1/4" LEDGE BLOCKOUT
 "VMB025"
 1 OF 2

1/4" LEDGE BLOCKOUT
"VMBO25"
2 OF 2

3/4" LEDGE BLOCKOUT
 "VMBO75"
 1 OF 2

1" LEDGE BLOCKOUT
 "VMB100"
 1 OF 2

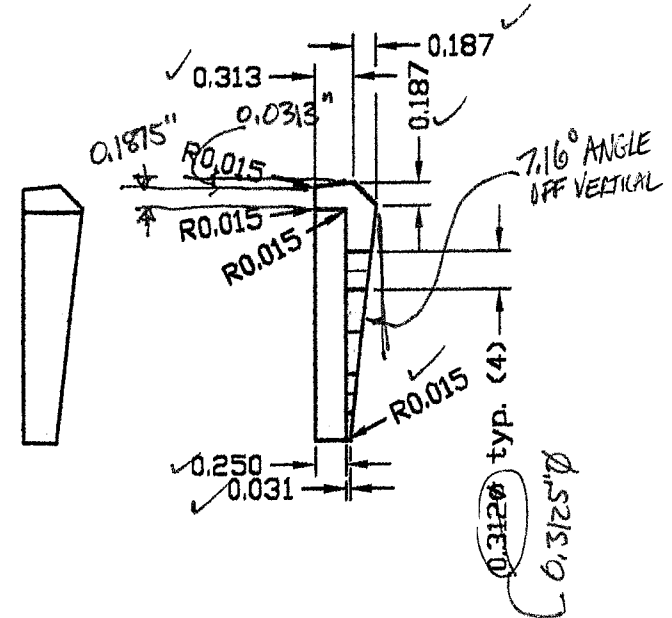
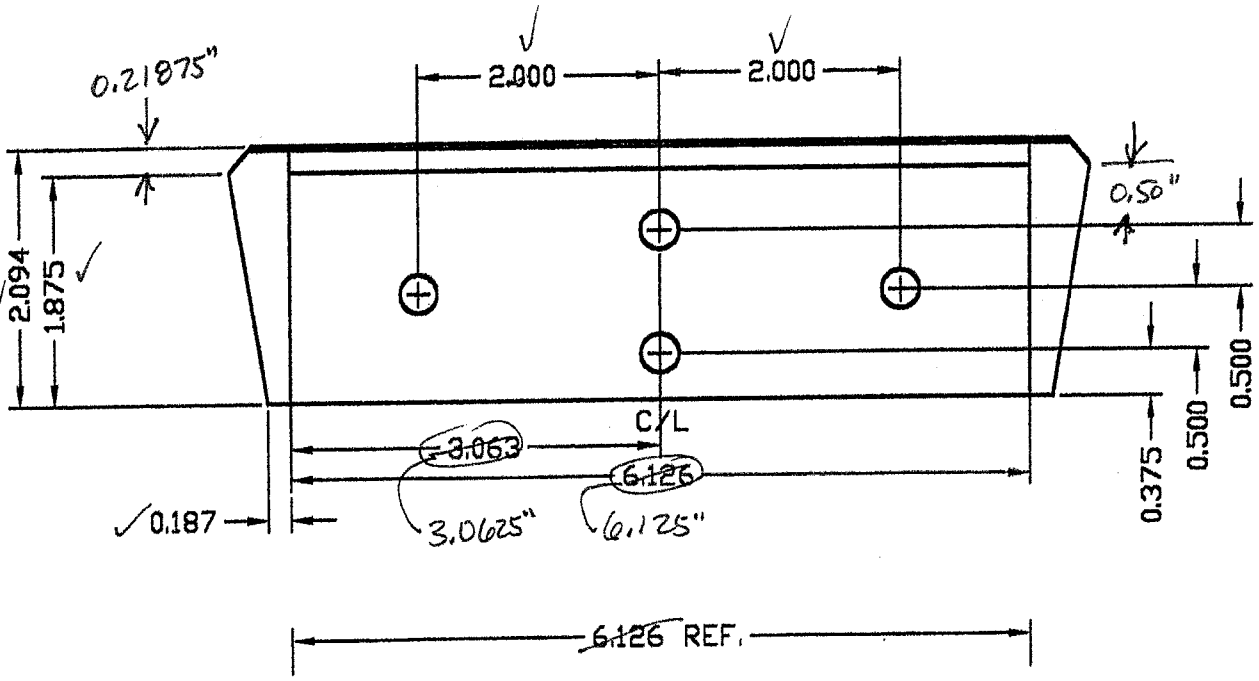
- NOTES:
- 1 - DIMENSIONS ARE WRONG, MATCH APPROVED "DST 7/29/02"
 - 2 - MISSING HOLE DIAMETER, DIMENSIONS, & RADIUS, MATCH APPROVED "DST 7/29/02"
 - 3 - MATCH CURVE OF VECTOR CONNECTOR SIDES - SEE "DST 7/29/02"

3/4" LEDGE BLOCKOUT
 "VMB075"
 2 OF 2

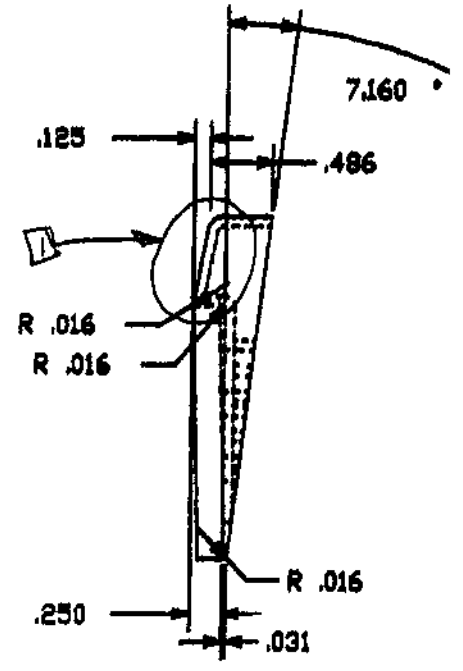
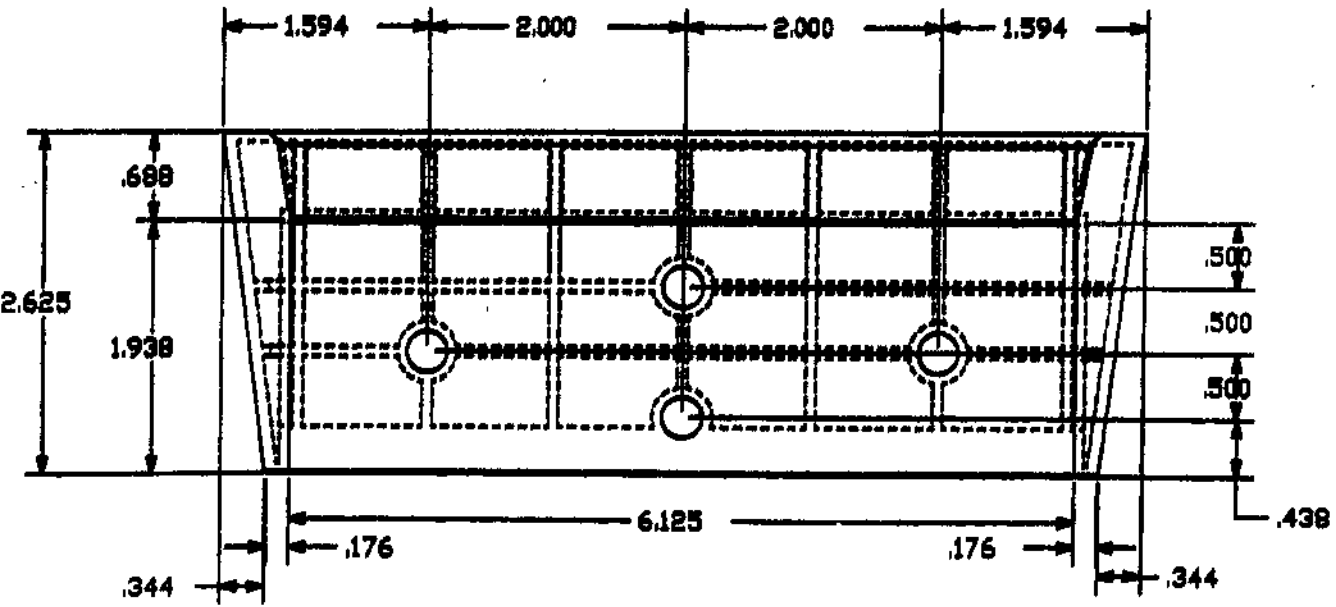
- NOTES:
- 1 - SEE ATTACHED DETAIL FOR CHANGE
 - 2 - HOLE DIAMETERS MISSING, MATCH APPROVED "DST 7/29/02"
 - 3 - RADIUS MISSING, MATCH APPROVED "DST 7/29/02"
 - 4 - MATCH CURVE OF VECTOR CONNECTOR SIDES - SEE "DST 7/29/02"

1" LEDGE BLOCKOUT
"VMB100"
2 OF 2

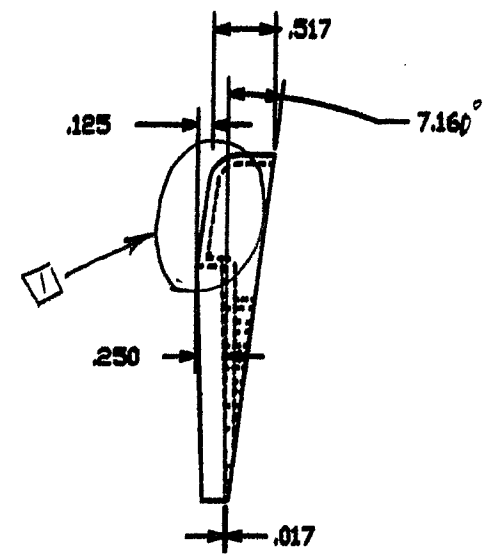
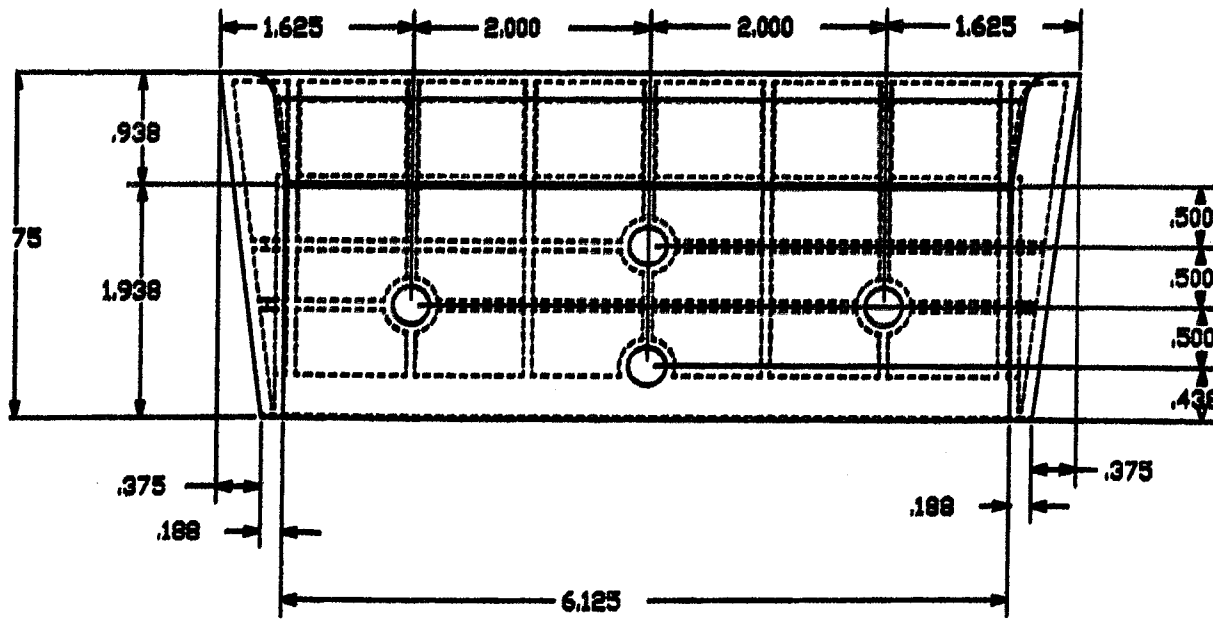
- NOTES: A - SEE ATTACHED DETAIL FOR CHANGE
 2 - HOLE DIAMETERS MISSING, MATCH APPROVED DRAWING "DSJ 7/29/02"
 3 - RADIUS MISSING, MATCH APPROVED DRAWING "DSJ 7/29/02"
B - MATCH CURVE OF VECTOR CONNECTOR SIDES - SEE "DSJ 7/29/02"
